**REQUEST**

Current Zoning: R-3 (single family residential)  
Proposed Zoning: B-2(CD) (general business, conditional)

Approximately 10.44 acres located on the west side of Reames Road, south of West W.T. Harris Boulevard.  
(Council District 2 - Harlow)

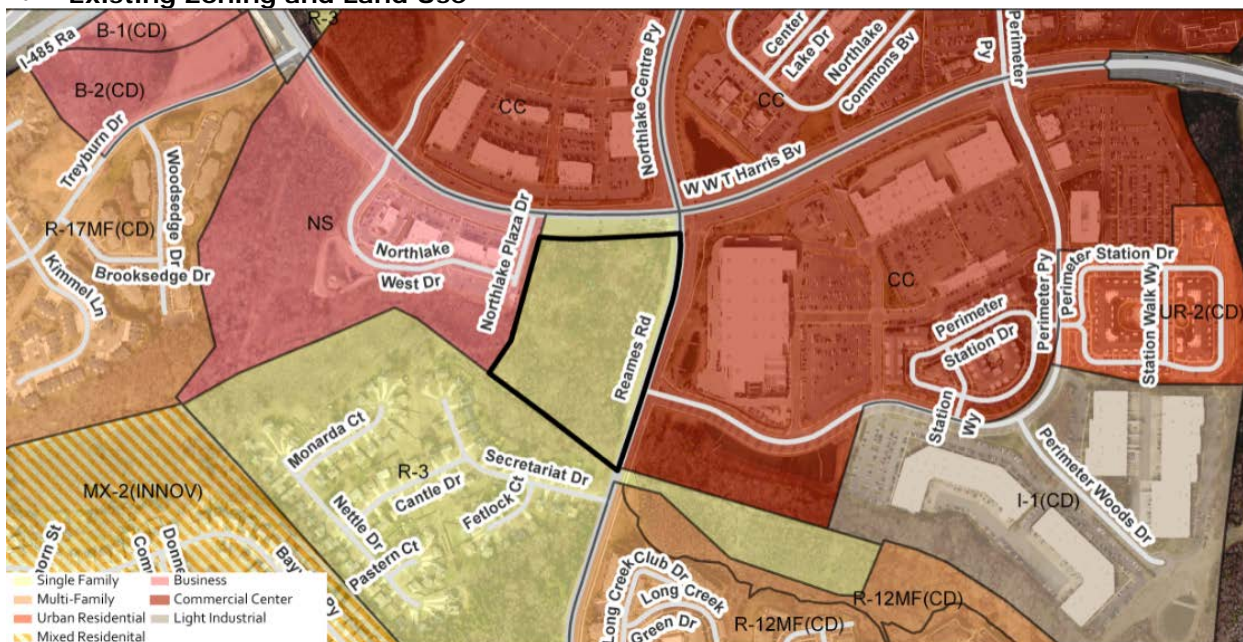
5. Connect sidewalk from Building C to sidewalk along West W.T. Harris Boulevard.
6. Pedestrian connections from Buildings A and B to the sidewalk along West W.T. Harris Boulevard need to align with another on the other side of the parking. Provide striping or raised walk/table in between. Please make proper adjustments to allow this to occur.

7. The limited planting areas adjacent to sections of the proposed private street will not permit the parking areas to be screened properly from the street and sidewalk. A five-foot minimum screening area or wall will be required.

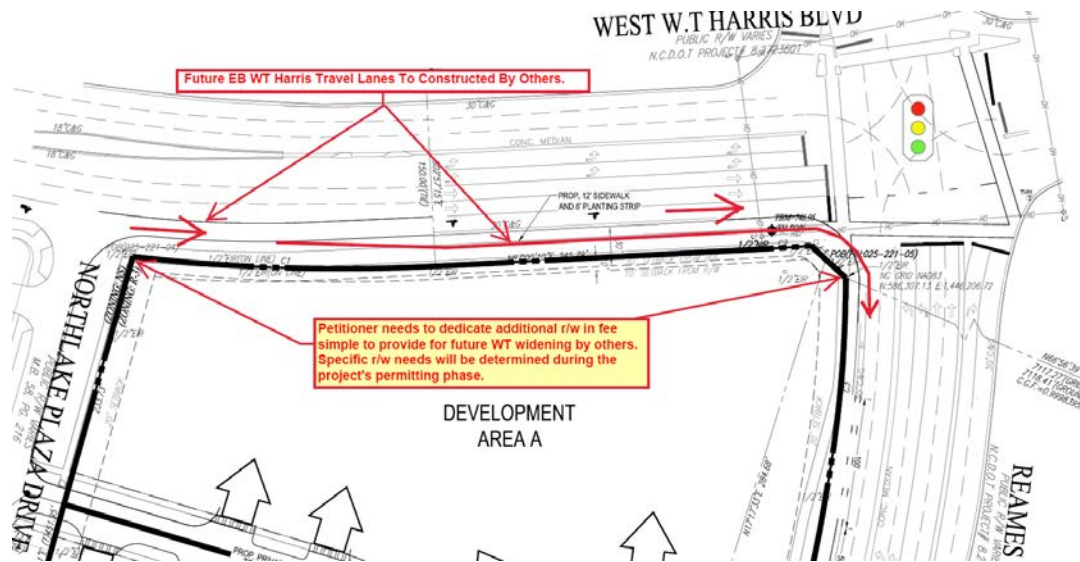
1. West W.T. Harris Boulevard's future widening plans calls for an additional through lane (12-foot width), including a separate 150' eastbound exclusive right-turn lane (12-foot width) with an appropriate bay taper length at Reames Road, and the area plan recommends a 20-foot planting strip and 8-foot sidewalk to support the walkability adjacent to this major arterial in the activity center along the site's WT Harris Boulevard frontage. The petition should revise the site plan to provide 32-foot of right-of-way (where the future thru and exclusive right turn lane coexists) as measure from the existing back-of-curb along the site's West W.T. Harris Boulevard frontage. (See exhibit below).
